**ATTACHMENT 3
LICENSE AMENDMENT REQUEST
EXTENDED POWER UPRATE**

**RENEWED FACILITY OPERATING LICENSE
AND
TECHNICAL SPECIFICATIONS
MARKUPS AND CLEAN PAGES**

**FLORIDA POWER & LIGHT
ST. LUCIE UNIT 2**

FIGURE 5.6 1f

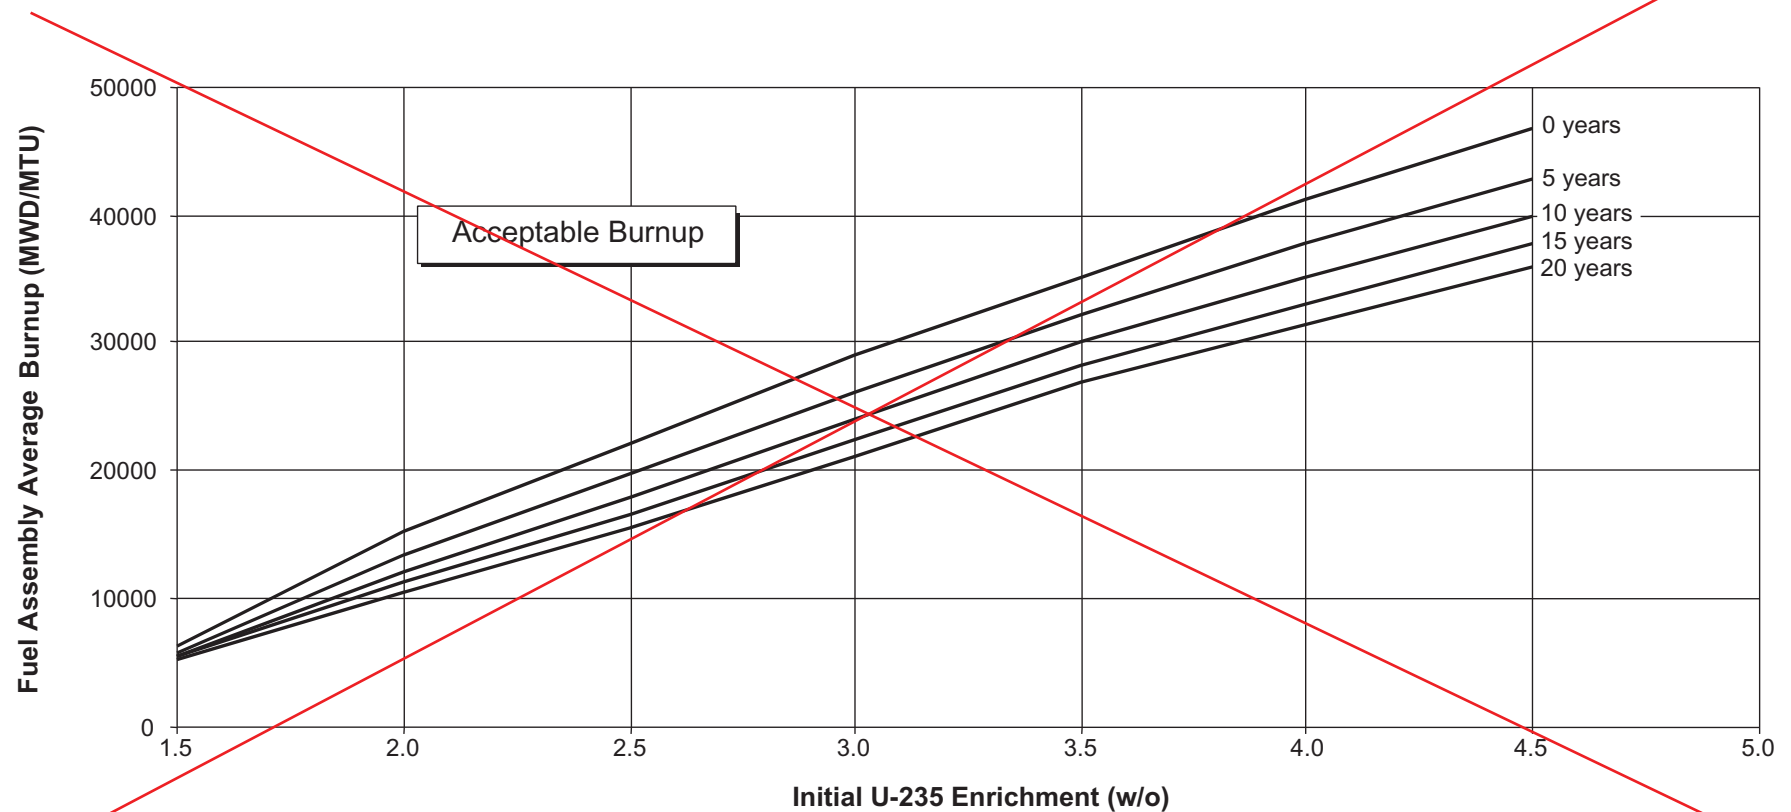
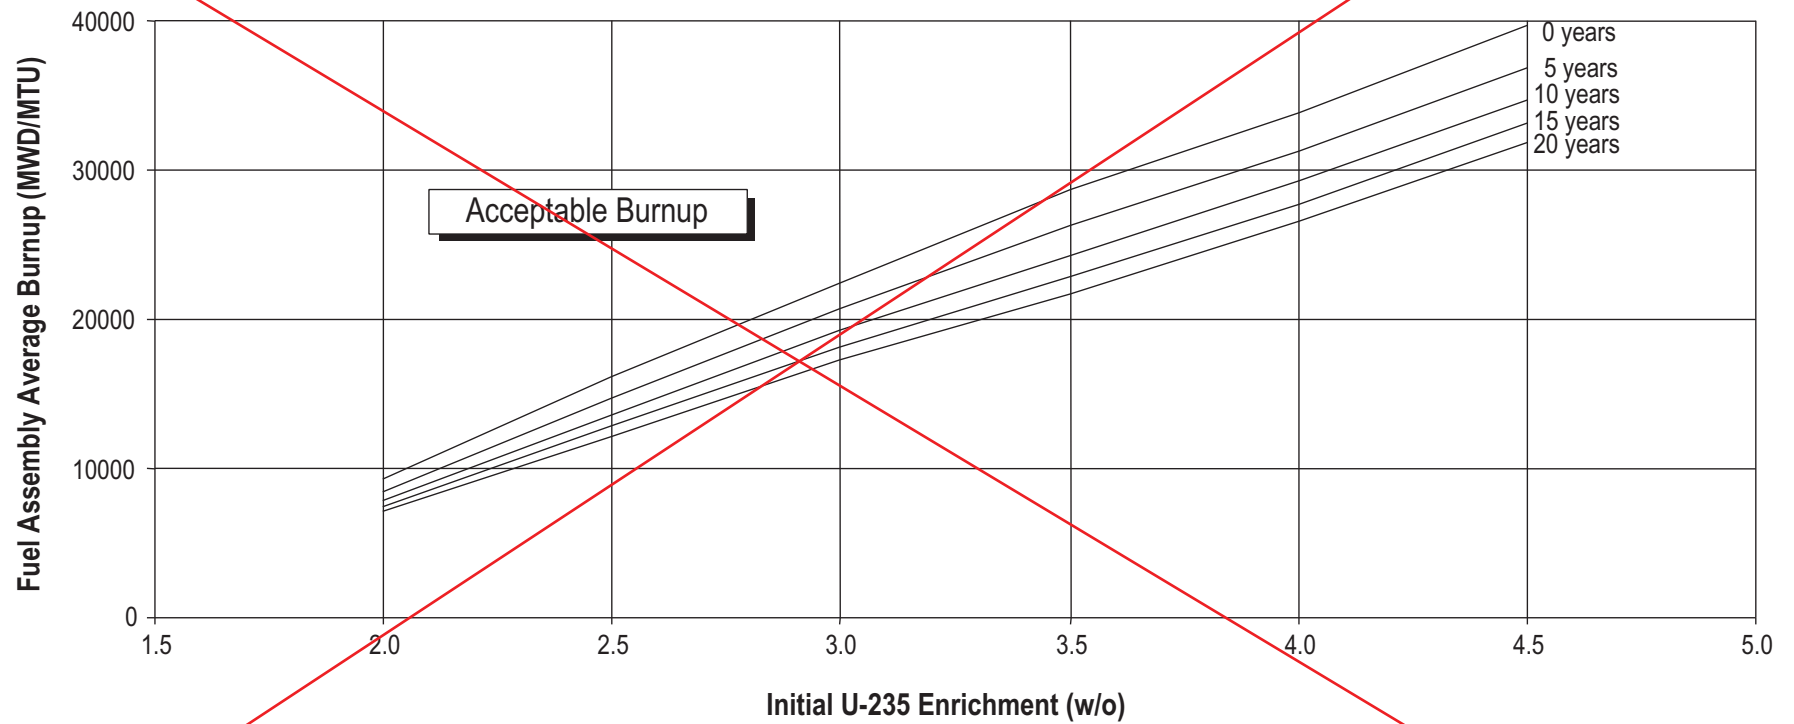
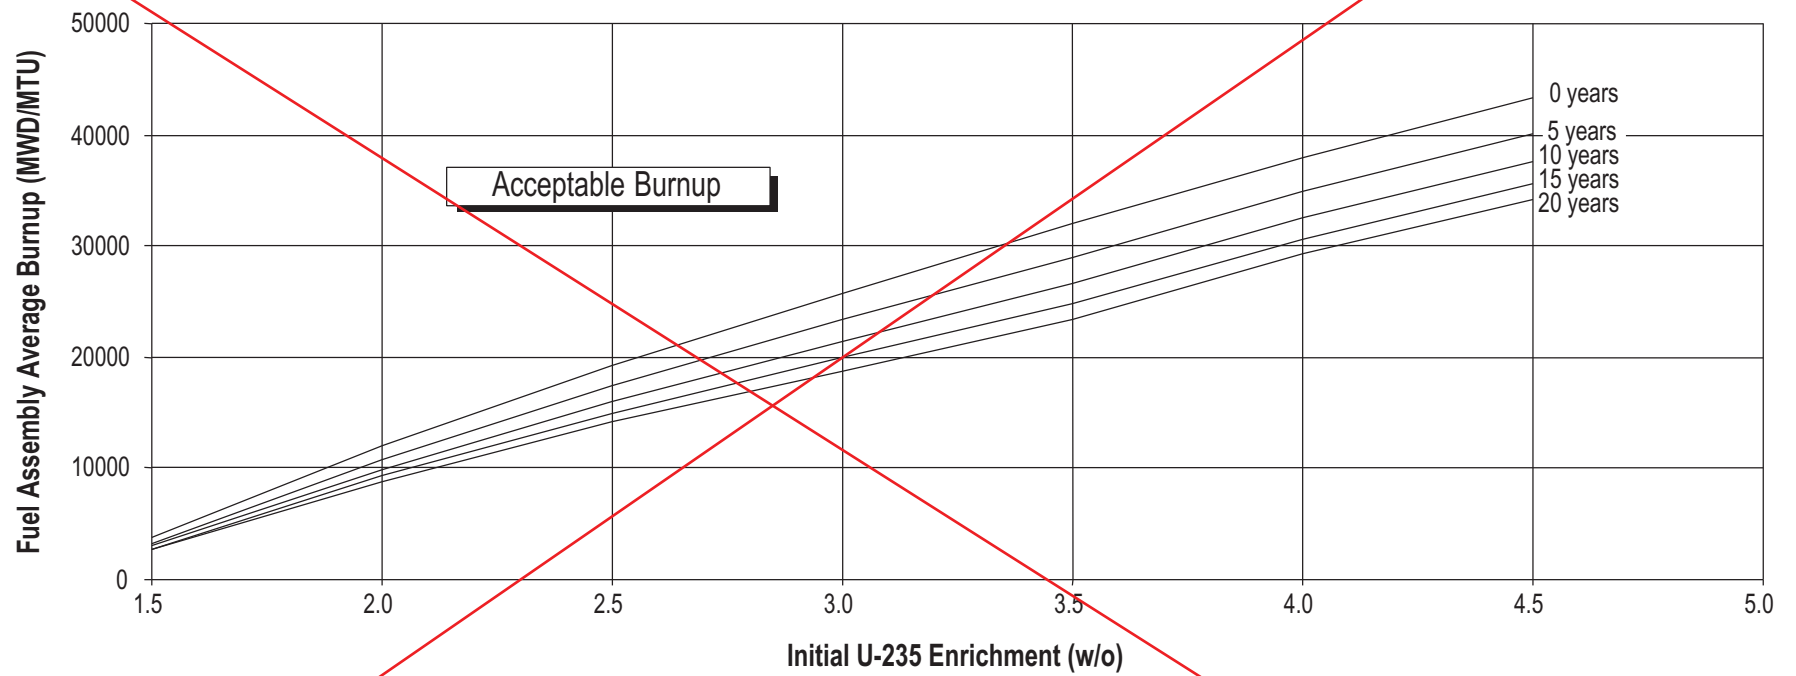
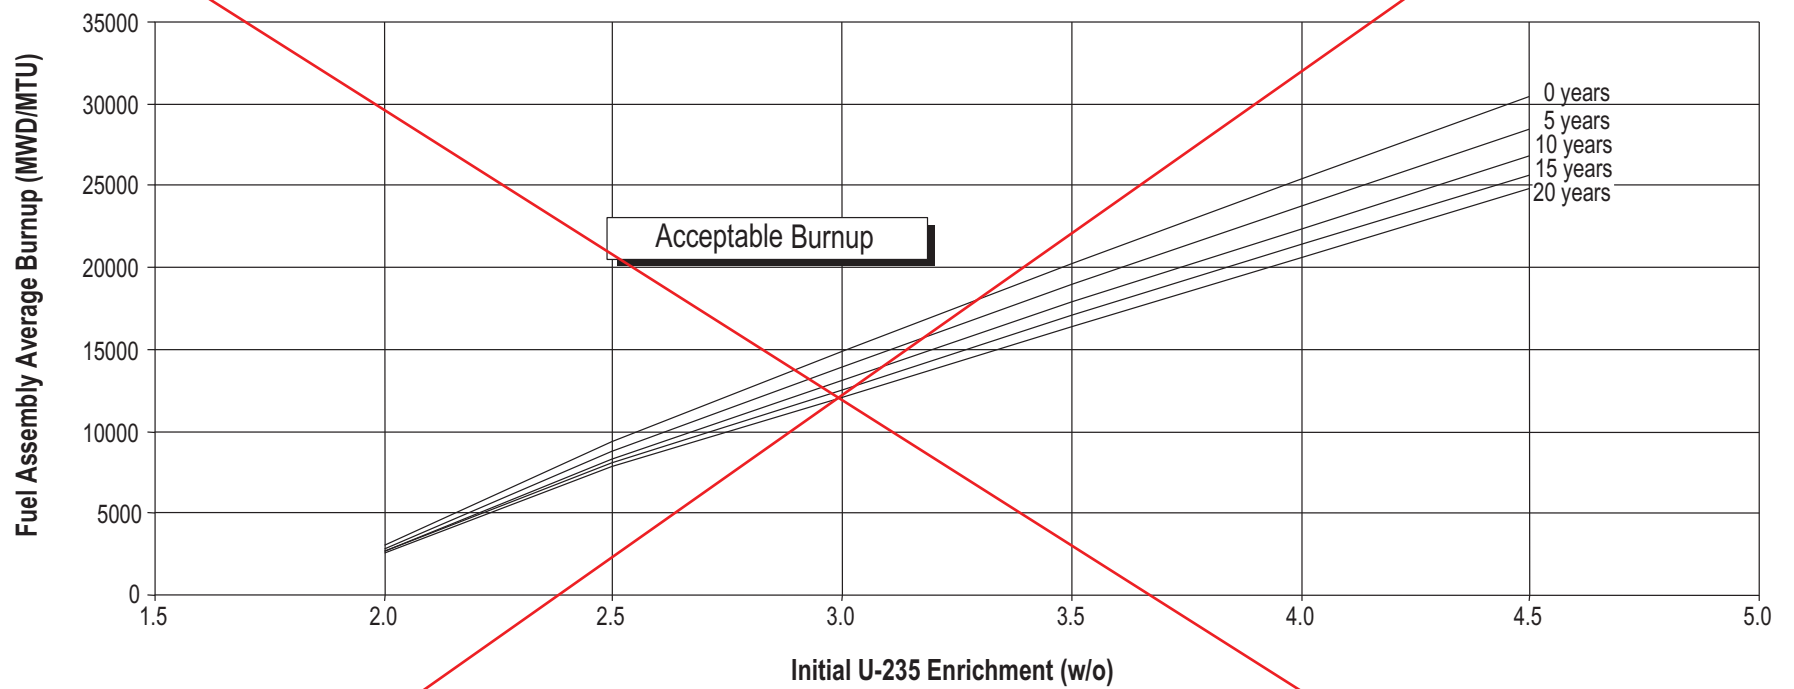
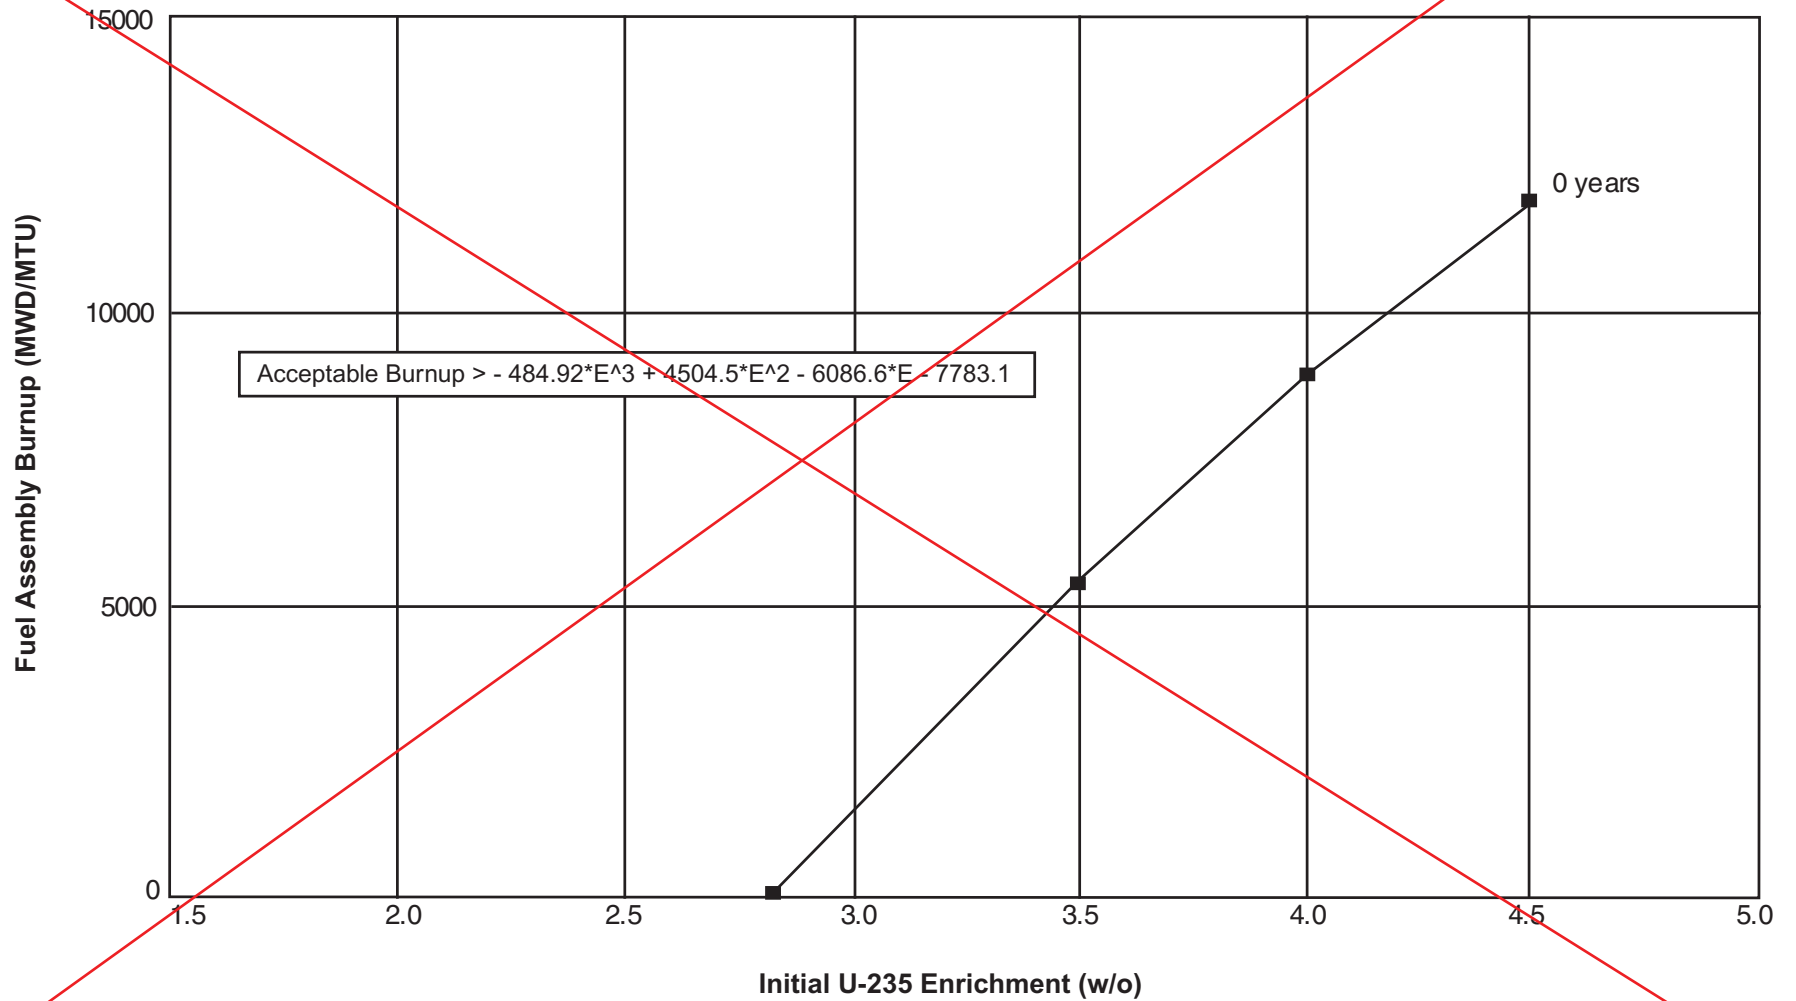
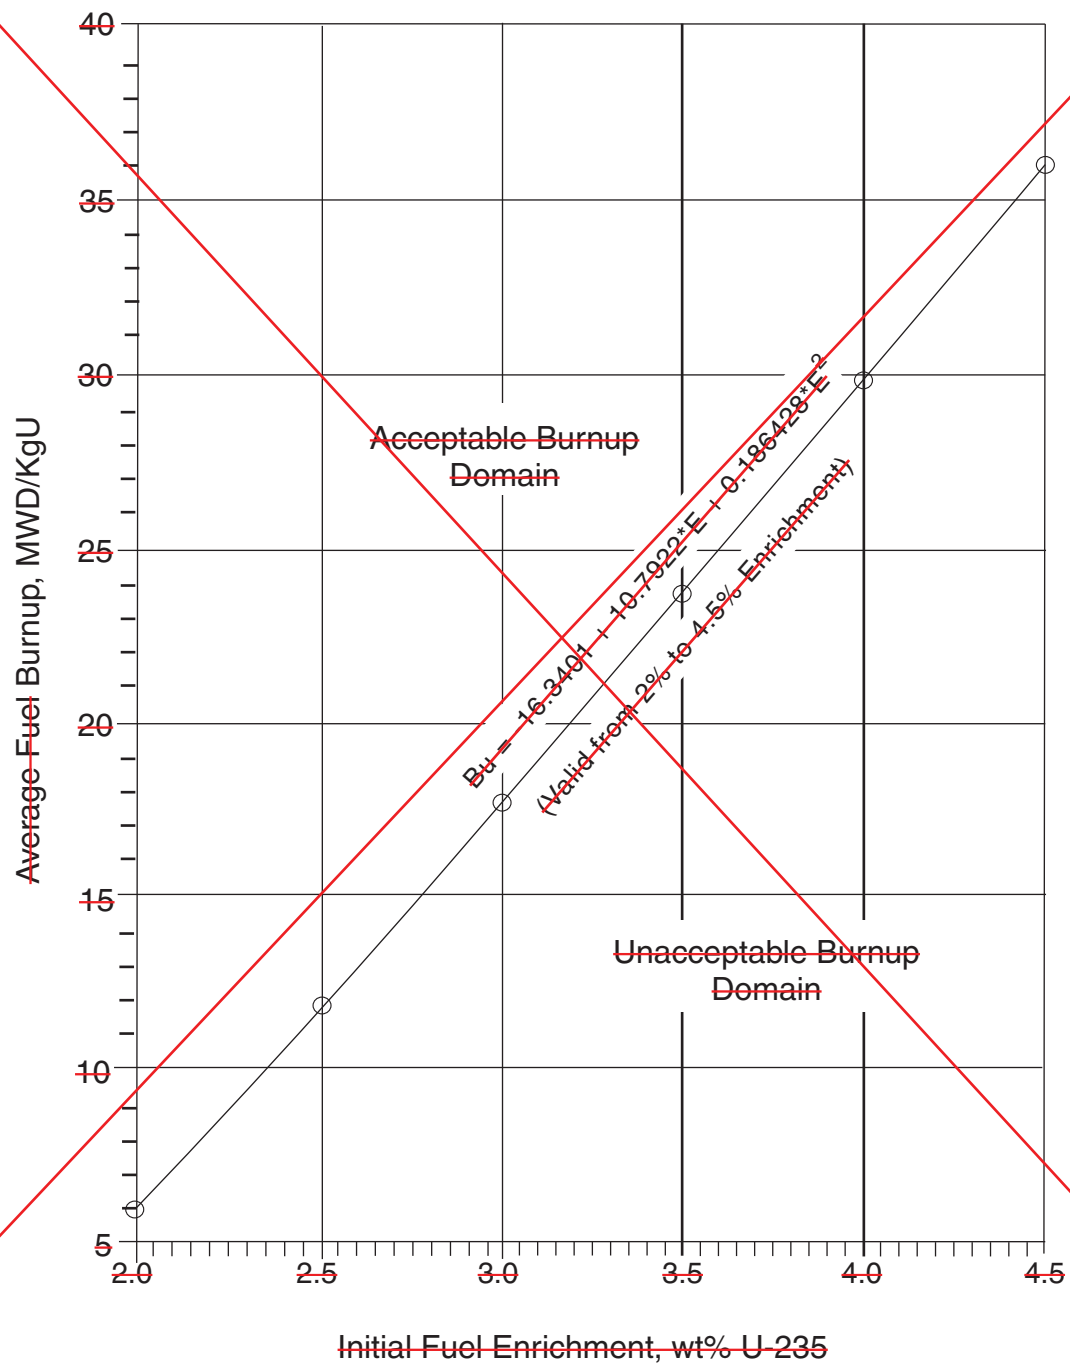
1. ~~Fuel placed in the Region II spent fuel pool storage racks shall meet the burnup and decay time requirements specified in Figure 5.6-1a or 5.6-1b. Fuel placed in the Region II cask pit storage rack shall meet the burnup requirements specified in Figure 5.6-1f.~~

Pages 5-4C through 5-4F (Amendment 101) and page 5-4G (Amendment 135) have been deleted from the Technical Specifications. The next page is 5-4h.

4.7-1 SAMPLING PLAN FOR SNUBBER FUNCTIONAL TEST	3/4 7-25
5.1-1 SITE AREA MAP	5-2
5.6-1a DELETED	
5.6-1b DELETED	
5.6-1c DELETED	
5.6-1d DELETED	
5.6-1e DELETED

5.6-1f DELETED	
5.6-1 ALLOWABLE REGION 1 STORAGE PATTERNS AND FUEL ARRANGEMENTS.....	5-4h
5.6-2 ALLOWABLE REGION 2 STORAGE PATTERNS AND FUEL ARRANGEMENTS (Sheet 1 of 3).....	5-4i
